PPIRM-77H

Answers

Re: FCC ID PPIRM-77H

Applicant: Nokia GmbH
Correspondence Reference Number: 29546

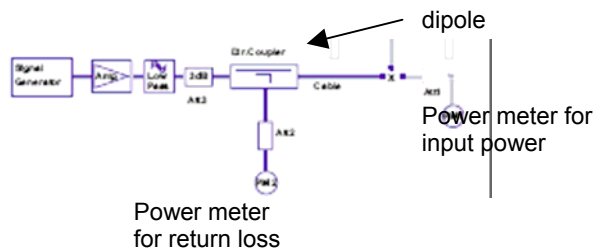
- 11) Please clarify information on the contour plots. Page 18 seems to report a value after exclusion while page 19 seems to report a value prior to the exclusion.

- The input signal was an unmodulated continuous wave, and average input power = 100mW after adjustment for return loss. The proper measurement of the 1cm probe to dipole separation, which is measured from the top surface of the dipole to the calibration reference point of the sensor, defined by the probe manufacturer. A dipole antenna meeting the requirements in PC63.19 was placed in the position normally occupied by the WD. The length of the dipole was scanned with both E-field and H-field probes and the maximum values for each were recorded.

Setup for desired output power to dipole:
